**Marion County
Board of County Commissioners**

**PLANNING & ZONING SECTION
STAFF REPORT**

| Case Number: | 241210ZP | |
| Type of Case: | Rezoning from General Agriculture (expired PUD) to PUD to allow for a total of 157 residential units | |

**Figure 2
Conceptual Plan**

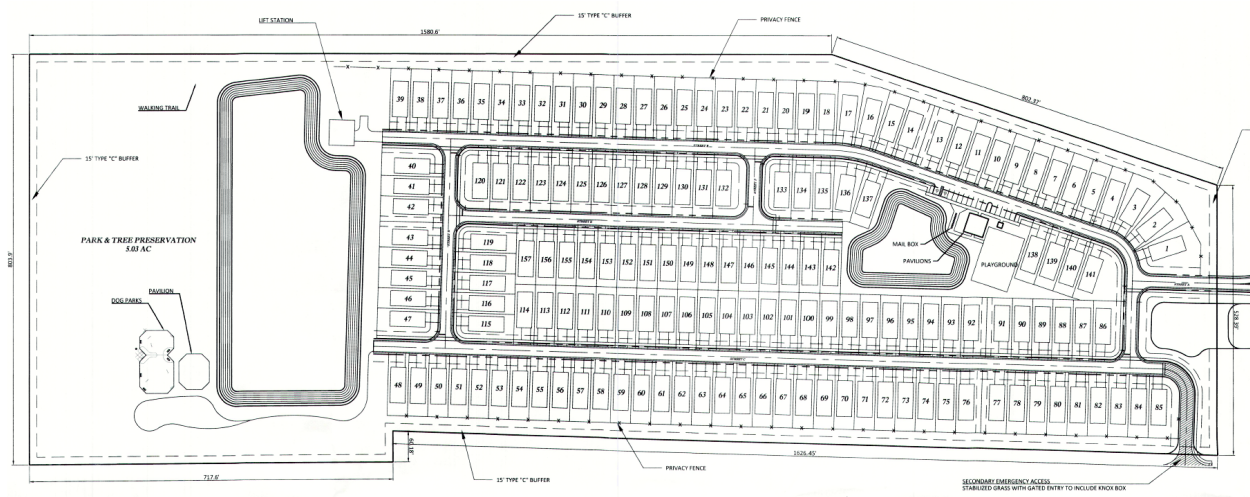
Growth Services Staff recommends that at least 158 dwelling units be developed to be consistent with the Marion County Comprehensive Plan. The overall proposed density for the PUD, with 157 detached single-family units, is 3.9 dwelling units per acre, which is below the minimum of 4 dwelling units per acre. The PUD proposes maximum building height of 50', and the architectural renderings depict two-story units. Lot typicals can be found in Attachment A, and propose 40' interior lot widths and a minimum width of 55' for the corner lots. The PUD proposes approximately 14.79 acres of open space, and within that open space the application proposes a playground area and a dog park. Figure 2 (also found in Attachment A) below shows the proposed conceptual plan with 157 proposed detached single-family lots, a playground, dog park, and pavilion.

The PUD does not address the heights of the homes along the southeast and southwest border. There is only mention in the concept plan and renderings of two-story units. One-story units would be more appropriate along the boundaries of the project that border one-story single-family residential lots to stay consistent with the neighboring single-story units, reserving the internal units, and the units along the rights of way for the two-story units.

Analysis: Staff finds the PUD proposes detached single-family homes on individual lots. The homes will have garages and parking is intended to be in the garage and on the individual driveways. Staff notes that the driveway length is shown on the Concept Plan to be 15' from the face of the garage to the right-of-way. Inside that 15' is the internal 5' sidewalk on at least one side of the right-of-way. Table 6.11-4 under Section 6.11.8 of the LDC, regarding Parking requirements, requires two (2) off-street parking spaces per single-family home with up to three (3) bedrooms, and requires three (3) parking spaces for single-family detached homes with four (4) or five (5)

Therefore, the PUD will be producing units where vehicles will be impeding the internal sidewalks, as there is not enough space for vehicles to park in front of the owner's house. This is **inconsistent** with this section.

However, the PUD does propose additional parking at the small neighborhood park, and the park is within walking distance of the entire PUD. Currently the Conceptual Plan proposes the parking spaces at the playground to back out into the subdivision road. Comments from OCE-Traffic do not address this but will address this issue during the Site Plan or Improvement Plan stage of Development Review.

- The PUD shall develop 158 detached single-family dwelling units, and accompanying accessory amenities consistent with the Marion County Land Development Code, the PUD Application, and PUD Concept Plan (Dated 9/20/2024; attached).
 - The PUD shall be restricted to one-story homes along the boundaries of the project.
2. LDC Section 4.2.31.B.(2) provides uses identified as ordinarily requiring a Special Use Permit may be authorized as permitted within all or a part of a PUD without the necessity of a separate SUP application provided it meets one of three criteria.

- All residential structures shall meet the 10' rear setback.
 - Accessory structures are limited to 20' in height.
5. LDC Section 4.2.31.B.(5) provides the intended character of the PUD shall be identified, including the structure types, architectural styles, ownership forms, amenities, and community management form (e.g., property owner association, community development classification, municipal service unit, etc.) or suitable alternative.
